#### Meeting Agenda

#### **Plat Committee**

Monday, January 23, 2023	6:30 PM	Betty J. Glick Assembly Chambers

Federal Addition to Seward Saltwater Safari Replat; KPB File 2022-184 Lang & Associates Inc. Saltwater Safari Properties LLC Location: C Street & Third Avenue City of Seward

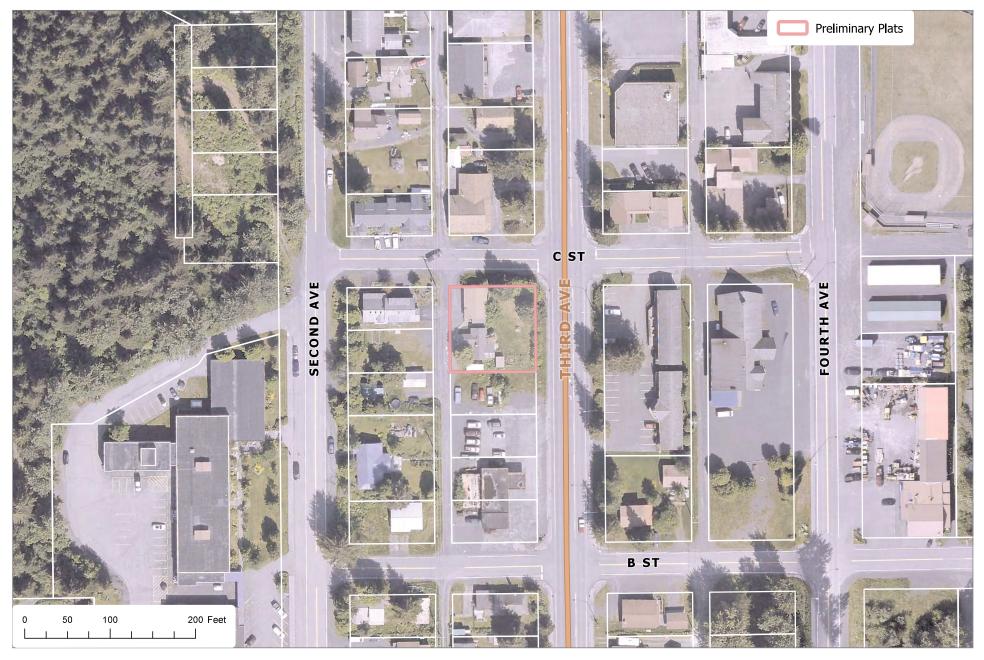
The preliminary plat has a small depiction with a detail with utilities shown. **Staff recommends** the smaller depiction is not required and unless being used to grant an easement, the utility information may be removed from the final.

Per KPB Code 20.30.0609(D), the front ten feet adjoining rights-of-way shall be designated as a utility easement. The plat does not indicate the intent to grant the easement and an exception was not requested. Per the same portion of code, if within the boundaries of an incorporated city, the width and location of utility easements may be determined by the city and affected utility providers. The information presented by the City of Seward Planning and Zoning Commission did not discuss the utility easements or a desire to reduce the code minimum of 10 feet. **Staff recommends** the plat grant the minimum 10 foot utility easements unless documentation is provided that the City of Seward wishes to reduce the amount or locations and all utility providers in the area agree to the changes.

#### Staff recommendation: Add "City of Seward" to where it is located.

Platting Staff Comments: City water and sewer available. Soils report will not be required. As the lots will be connecting to an existing system and on site will note be available, the plat note should be updated to "Plans for wastewater disposal that meet regulatory requirements are on file at the Department of Environmental Conservation."

**Staff recommendation**: The current Notary Acknowledgment is a combination of acknowledgement and jurat. Either change to a Notary Jurat or remove "sworn" form the acknowledgment. The Certificate of ownership will require rewording. "I, hereby certify that Saltwater Safari Properties, LLC is the owner of the real property shown and described hereon and that I, on behalf of Saltwater Safari Properties, LLC, hereby adopt this plan of subdivision and by my free consent dedicate all rights-of-way and public areas to public use and grant all easements to the use shown." Additional documentation will be required to verify who is allowed to sign on behalf of the LLC and if additional member signatures will be required. If so the certificate of ownership should be changed to plural pronouns. Comply with 20.60.190.

E3-15

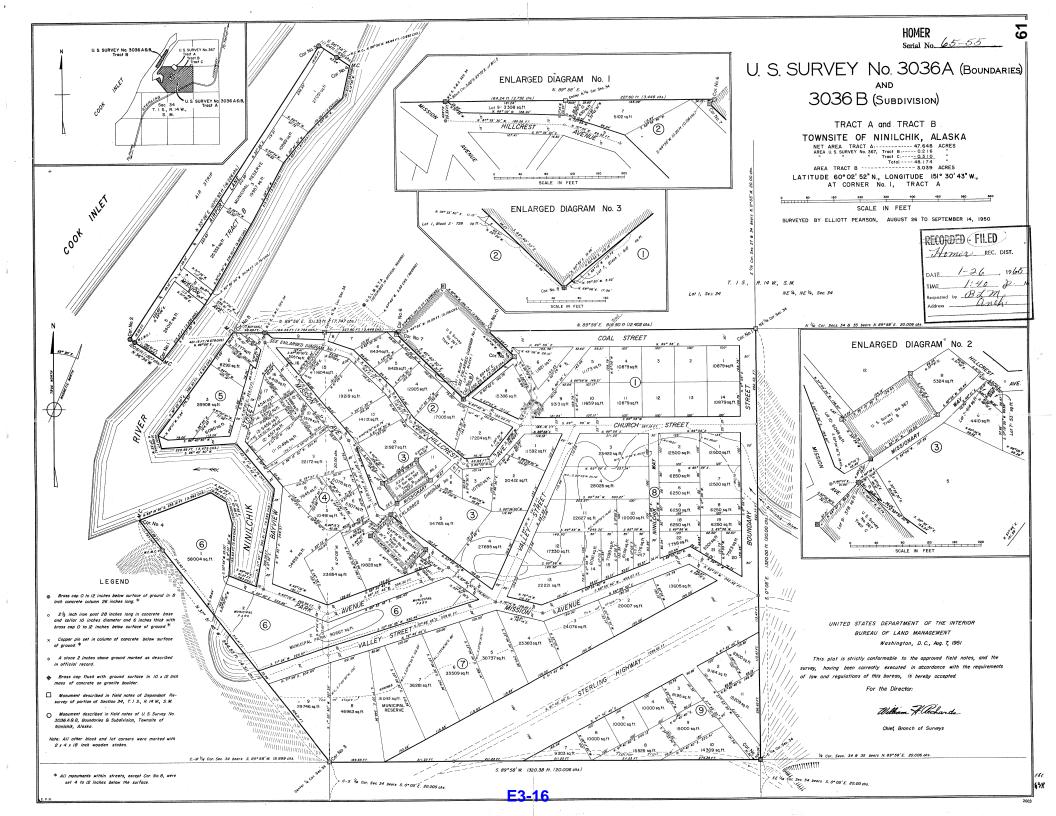
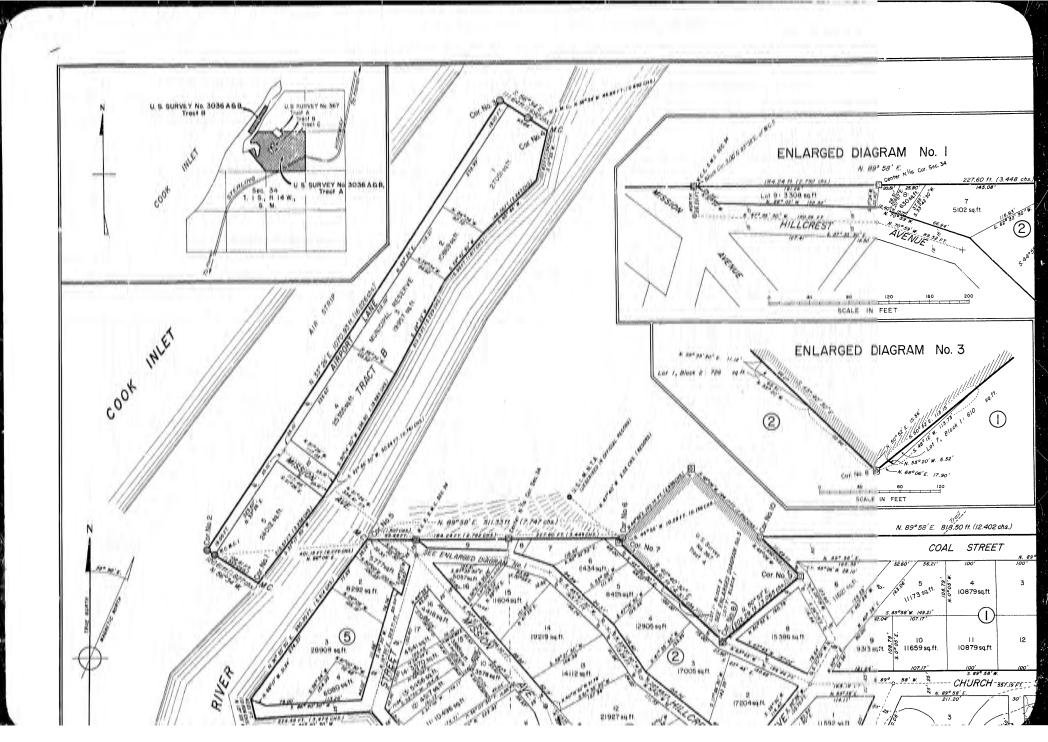
The property shows the 2022 surveyed meander of the Ninilchik River. **Staff recommends** the source or method for finding the meander should be noted or provided within a note, and a note regarding natural meander is for computations only should be added.

The proposed subdivision is within multiple Flood Hazard Zones. The majority is within X which is minimal risk and is non-regulatory. Portions within the western and southern areas are within AE zone. The AE zone is regulatory and has a 1% annual chance of flooding. *Staff recommends* the AE zone boundary be shown on the plat and the required flood hazard note be added.

Update the plat note numbers. Add KPB number

**Staff recommendation:** Provide a width label for the portion of Bayview Street located south of the plat even though the river takes up a portion.

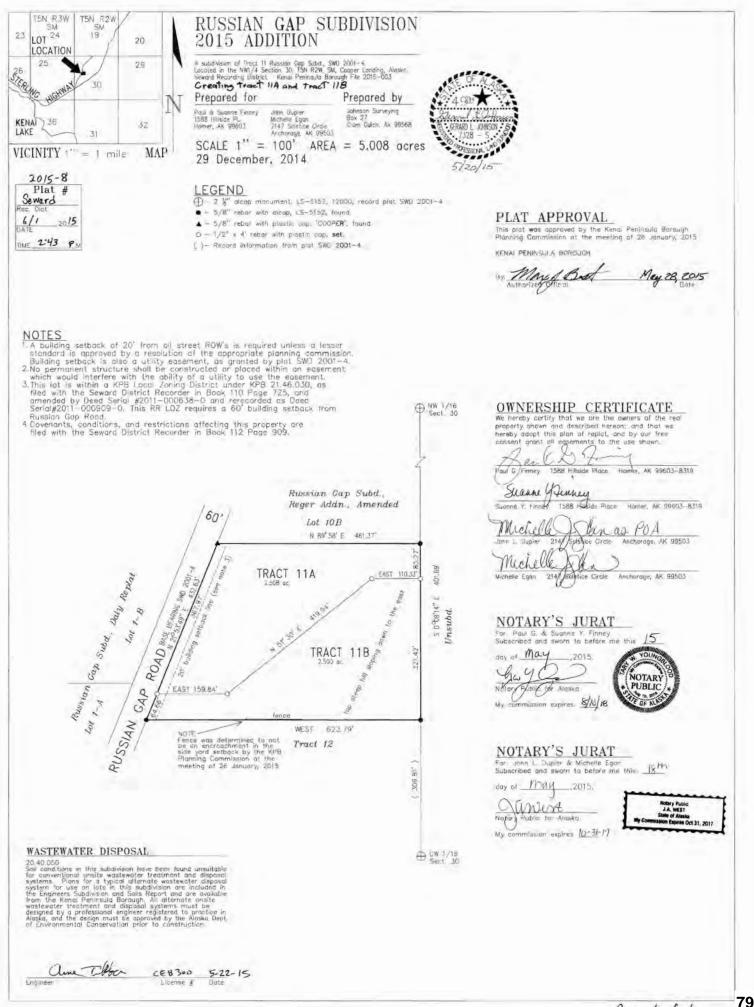
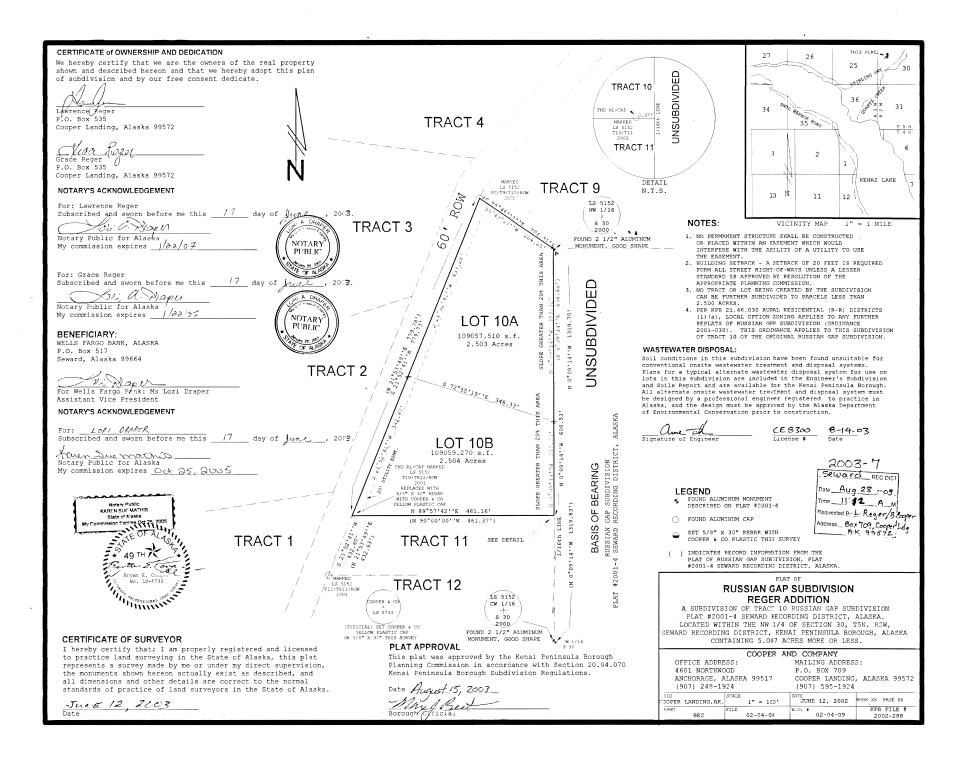
<u>Site Investigation</u>: Steep areas are present and shown. They are mostly within the eastern portion of the subdivision. **Staff recommends** the steep terrain be removed and plat note 5 remove the portion regarding contours.

<u>Utility Easements</u> Russian Gap Subdivision, SW 2001-4, granted a 20 foot utility easement adjacent to the Russian Gap Road dedication. The easement was carried over onto the replats. *Staff recommends* the depiction, labeling, and notes be revised to carry over the 20 foot utility easement.

Add legend to drawing

**Staff recommendation:** Update Tract 10B to "Lot". Remove "Amended" from the parent subdivision name.

Staff recommendation: Label Russian Gap Road and provide a right-of-way width label.

**Staff recommendation:** Remove "Amended" from the subdivision label to the north. Provide the depiction of Russian Gap Road and lots west of the right-of-way.

**Staff recommendation:** Per code all setbacks shall be depicted. Per the code for RR LOZD, the property is subject to the following setbacks, 60 foot front, 25 side lot lines, and 40 rear. Provide depiction and labels and provide a reference to the plat note for setbacks.

- Plat note 1 Remove to provide new notes stated above.
- Plat note 3 "These lots are within Russian Gap Subdivision Local Option Zoning District with notice recorded with the Seward Recording District in Book 110 Page 725, amendments within Serial Number 2011-000638, 2011-000909-0, and 2020-001405-0."
- Plat note 4 add "...and Book 111 Page 105."

Plat note 5 – remove "Contour interval 4'." Leave the remainder of the note on the final.
